Docket Item # 13  
BAR CASE # 2006-0278

BAR Meeting  
December 20, 2006

**ISSUE:** Addition and alterations

**LOCATION:** 219 South Royal Street

**Figure 1 – Front elevation**

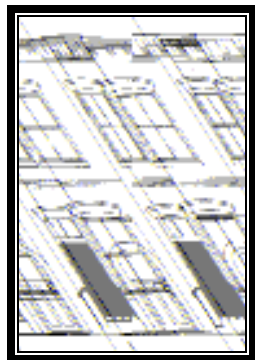
With respect to windows, Staff notes that the *Design Guidelines* recommend the use of true-divided-light windows and discourage the use of simulated divided light windows except in areas with minimal visibility from the public way (Windows – Page 2). However, Staff believes the use of simulated divided light windows and doors would be appropriate for the addition as it is new construction and the windows are well removed from public view. On the other hand, Staff believes the new windows to be installed in the front façade of the historic brick section should

be true-divided-light windows. These windows are immediately adjacent to the sidewalk and highly visible. As explained in docket item #12, Staff believes the two standard, rectangular window openings in the south wall of the brick section should be retained. If retained, these should also have true divided light replacement windows.

As noted above, it is not clear whether the existing six panel front door is to be replaced. If the door is replaced, the new door should be appropriate to the Victorian appearance of the brick front section and should be approved by Staff prior to installation.

1. That the fiber cement siding be smooth and installed so that the nails do not show;
2. That any replacement windows in the brick section be true-divided-light windows;
3. That the front door, if replaced, be appropriate to the Victorian period of the brick portion of the house and be approved by Staff prior to installation;
4. That the skylights have integral shades; and,
5. That the following statement must appear in the General Notes of all site plans and on all site plan sheets that involve demolition or ground disturbance (including sheeting and shoring and grading) so that on-site contractors are aware of the requirement:
